Title of Change:	UPDATE PIN NUMBERING FOR DEVICES SIDA-DIODE CASE OUTLINE 369AS
Effective date:	21 Dec 2023
Contact information:	Contact your local onsemi Sales Office or Huan.Tran@onsemi.com
Type of notification:	This Product Bulletin is for notification purposes only. onsemi will proceed with implementation of this change upon publication of this Product Bulletin.
Change Category:	Update pin numbering & case outline 369AS
Change Sub-Category(s):	Datasheet/Product Doc change

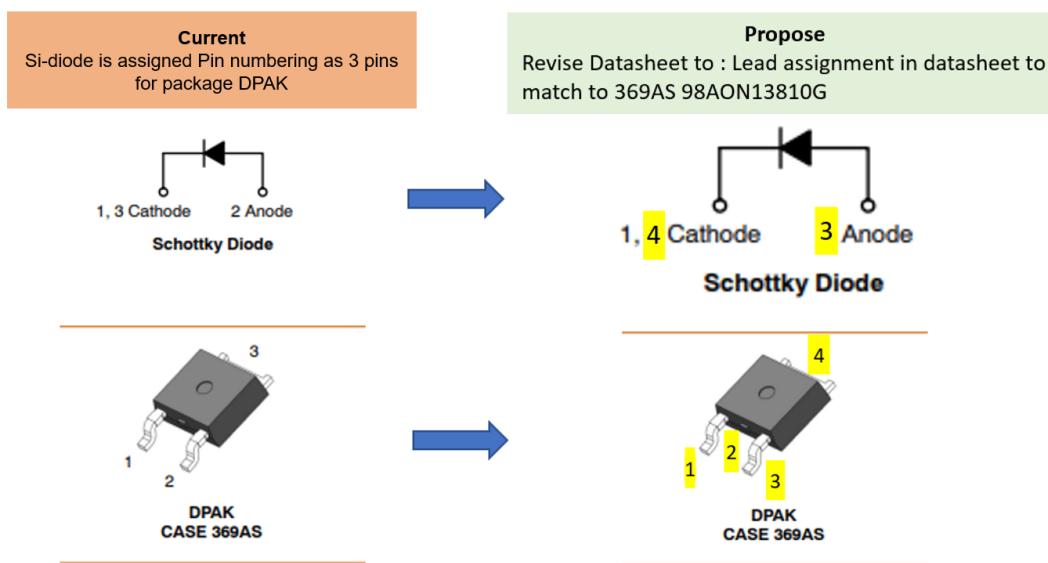
onsemi wishes to inform you that list affected standard SIDA-Diode parts are updated pin numbering for case outline 369AS on data sheet. The change will not impact form, fit, or function of products.
